**From:** John Lai  
**Sent:** Thursday, April 03, 2008 8:46 AM  
**To:** George Wunder  
**Cc:** Glenn Kelly; Hossein Hamzehee  
**Subject:** FW: Information from ABWR SSAR  
**Attachments:** 20\_03\_09.pdf

The attached file contains GE responses to the Ninth set of RAIs on the ABWR SSAR. Questions 725.43, 725.44, and 725.45 reference the transmittal of CAFTA and MAAP input files to the NRC. This is all of the additional information I have right now. I'm not sure of the dates of the RAI or the responses, although it was probably in the mid 90s.

### 20.3.9 Response to Ninth RAI — Reference 9

**Figure 20.3.9-16 Characteristic Response for Damped and Undamped Systems (Response to Question 725.53)**

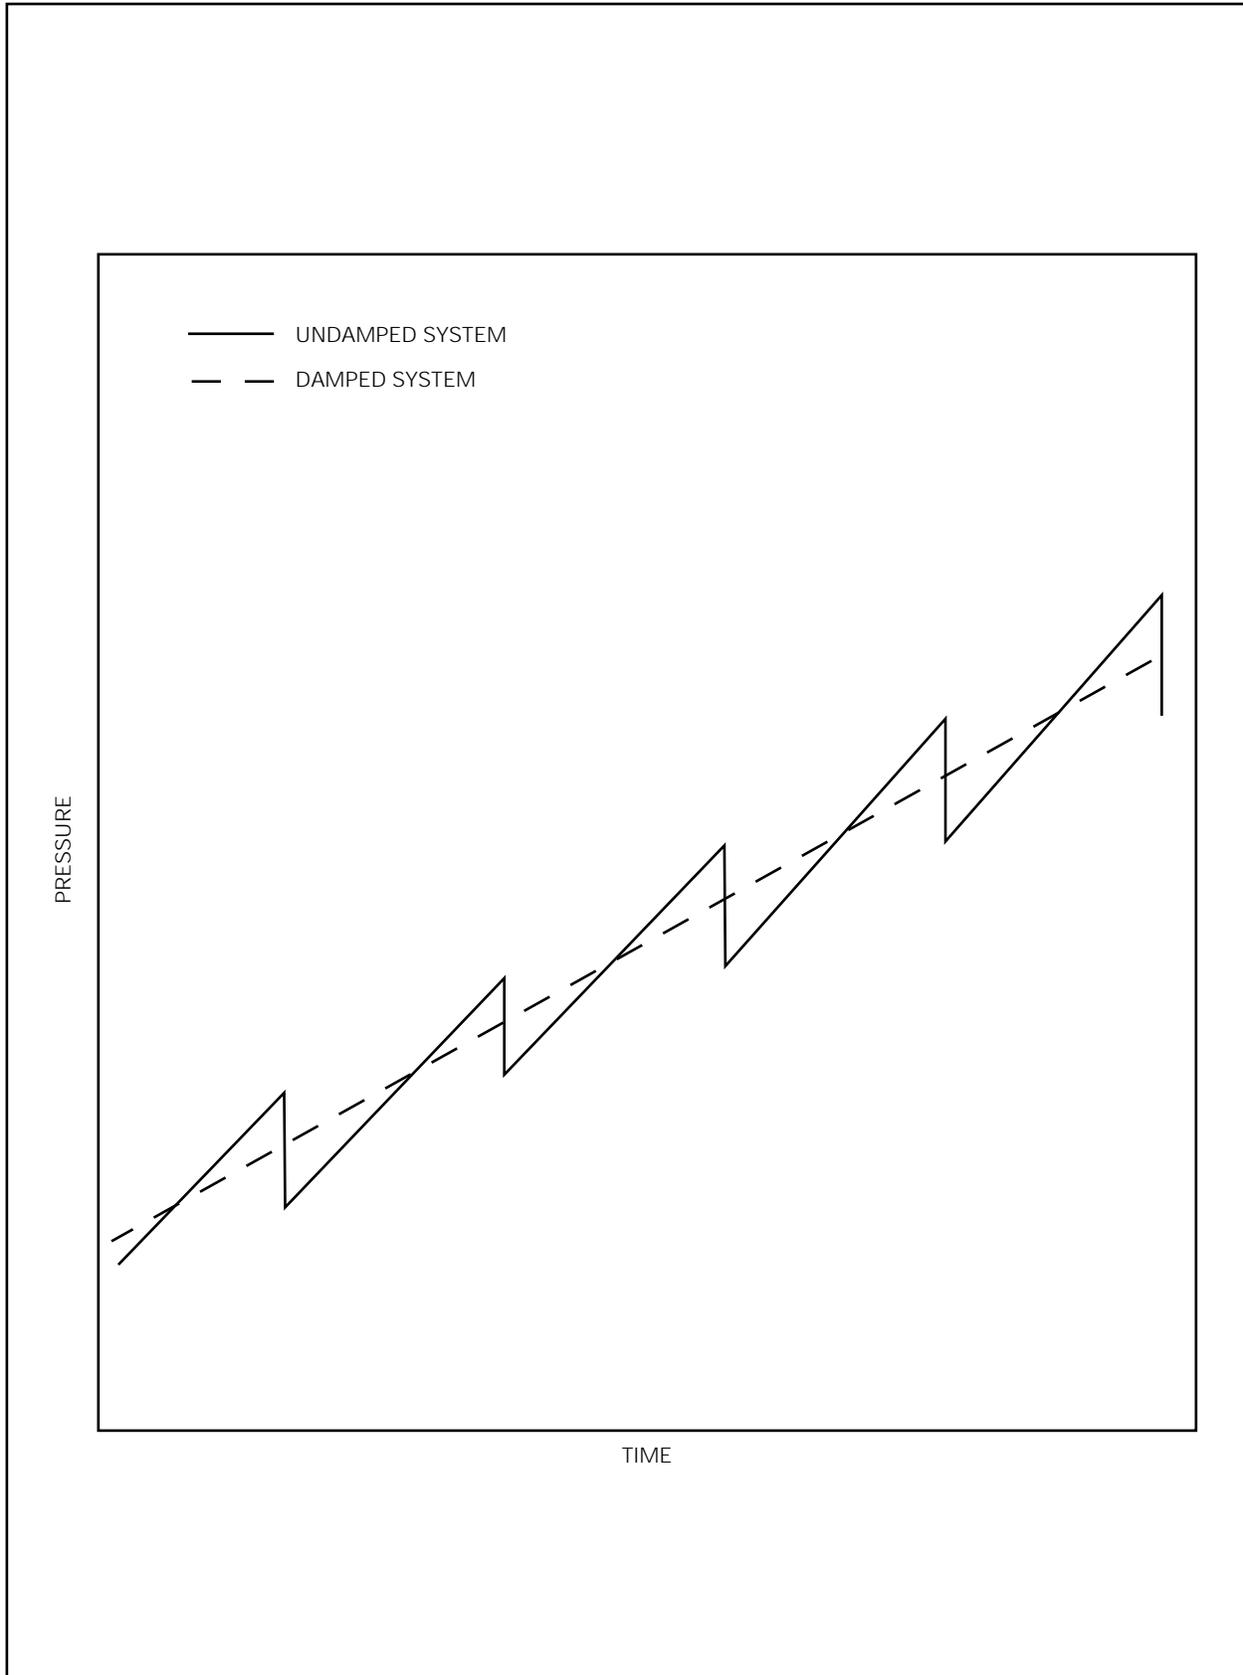
Referring to Figures 19E.2-5 (Accident Sequence LCHPPFPH): Figure A shows a pressure drop at about 17 hours. This was explained in the text as being due to the flow of water from the suppression pool into the drywell (A similar phenomenon was shown in Figure 19E.2-11.). Please clarify. It appears that the DW pressure should be higher than the WW pressure during this period. This pressure drop appears to delay the DW head failure by about 10 hours. What impact will this have on the final release fraction?

As discussed in the response to Question 725.52b, the changing water level, and the resulting pressure drop, are the result of a physical instability. The magnitude of the pressure drop (also observable in Figure 19E.2-2B) is amplified in this case because the partial pressure of noncondensable gases is lower in this case due to the leakage from the containment through the penetration seals in the drywell. This leakage also causes duration of the pressure correction to be increased.

Extrapolating the pressurization rate shown in Figure 19E.2-5 in order to determine the drywell head failure time is incorrect. If drywell head failure had not occurred, a second pressure correction would have been observed, resulting in a sawtooth pattern as shown by the sketch of undamped system response in Figure 20.3.9-16. Clearly, extrapolating the pressure using the slope of the curve during the time pressure is overly conservative. The pressure of a damped system would lie between the peaks of this response, as indicated by the sketch of the overdamped system response. One cannot extrapolate the pressurization rate based on a single incomplete cycle. Furthermore, the actual containment failure time will be dependent on the degree of damping in the system.

To estimate the uncertainty in the time to containment failure and the fission product release, a modification to MAAP was made which limited the flow of water from the passive flooder. It was assumed that the flow rate is equal to the mass of water which can be boiled away by decay heat, this serves to overdamp the pressure response. The pressurization of the containment using this assumption was very smooth. Rupture of the drywell head occurred at 35.7 hours compared with 37.0 hours for the undamped case shown in Figure 19E.2-5. The release rate of fission products is very similar to that of the base case. The final release fraction of CsI was about 12%, the same as the base case.

Figure 20.3.9-17 Pressure Time History After a Feedwater Line Break Available ECCS: 1 RHR System

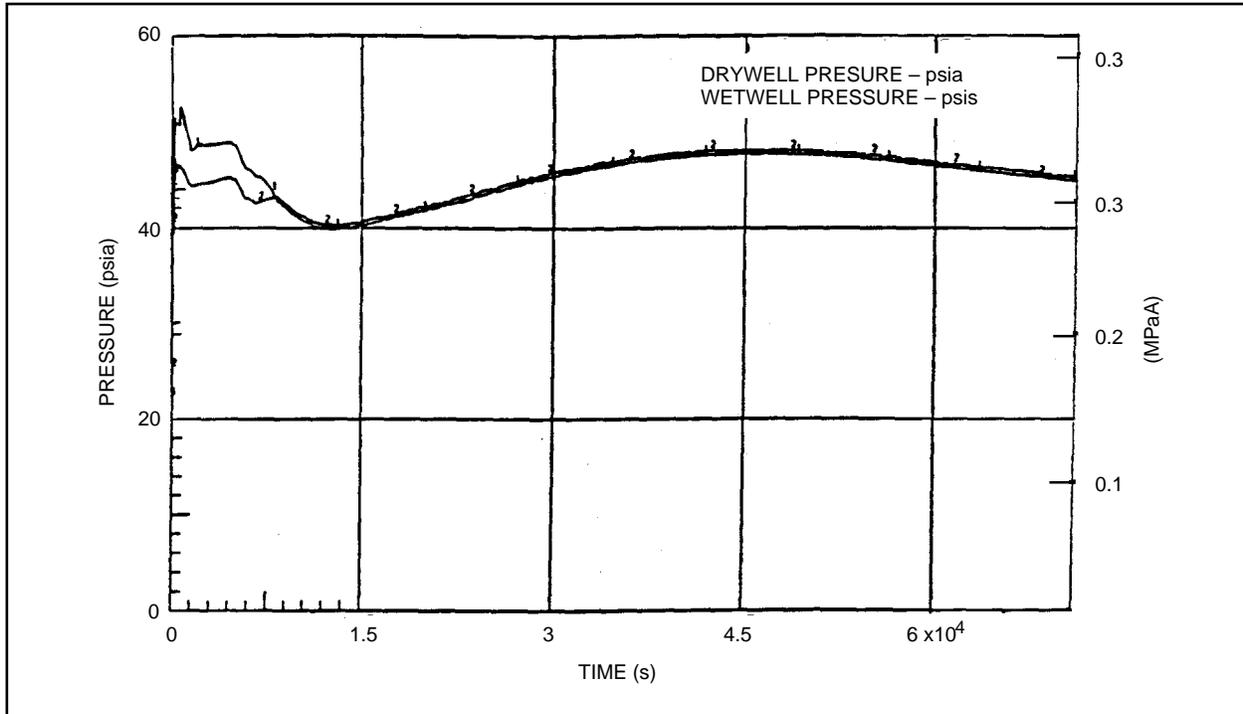
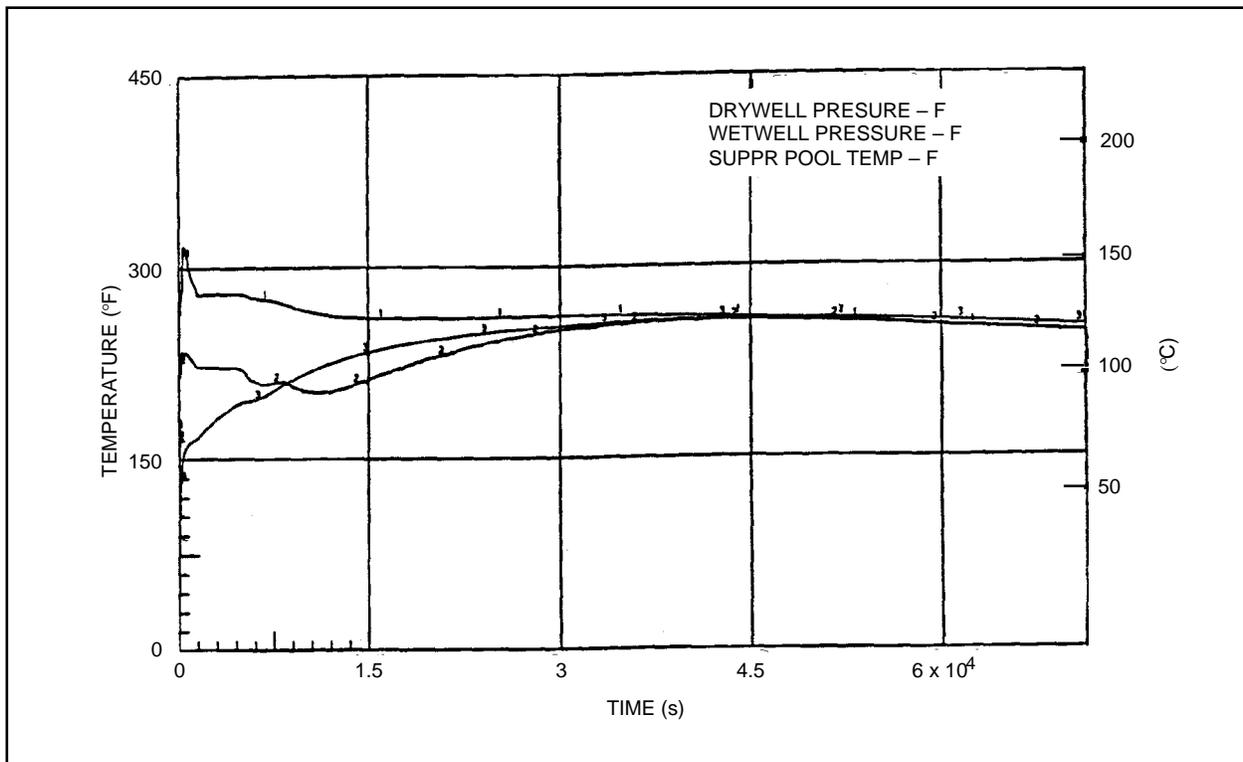
In essentially all of the event trees shown in Fig. 19D.4-1 through Fig. 19D.4-14, failure of the W function (long term heat removal) is assigned a probability of failing to run RHRA or RHRB or RHRC rather than failing to start and run RHRA or RHRB or RHRC, if the preceding V function (RHR injection or condenser) is a success. This would be correct if one of the RHR pumps was successfully started and run to accomplish the mission of the V function, and then switched to a long term heat removal mode. Notice, however that the success of the V function can also be achieved, as indicated in Table 19.3-2, by using one condenser pump and one condenser transfer pump. In such a case, the approach taken in the ABWR FSR will underestimate the failure probability of W since the RHR pump has to be started and then run throughout the mission time. Also, can one RHR pump alone always accomplish the missions of both the V and the W functions for all the transients including a large LOCA?

The containment pressure and temperature responses for a feedwater line break are shown in Figures 20.3.9-17 and 20.3.9-18, respectively. The calculated maximum pressure and temperature values are about 0.366 MPaA and 158.9°C, respectively. These maximum values are substantially lower than the ultimate pressure capability of the containment structure (0.62 MPaG at 371.1°C) defined in SSAR Appendix 19F.

Based on the results of the above analysis, it was concluded that 1 RHR system provides sufficient long-term heat removal capability to assure containment structure integrity.
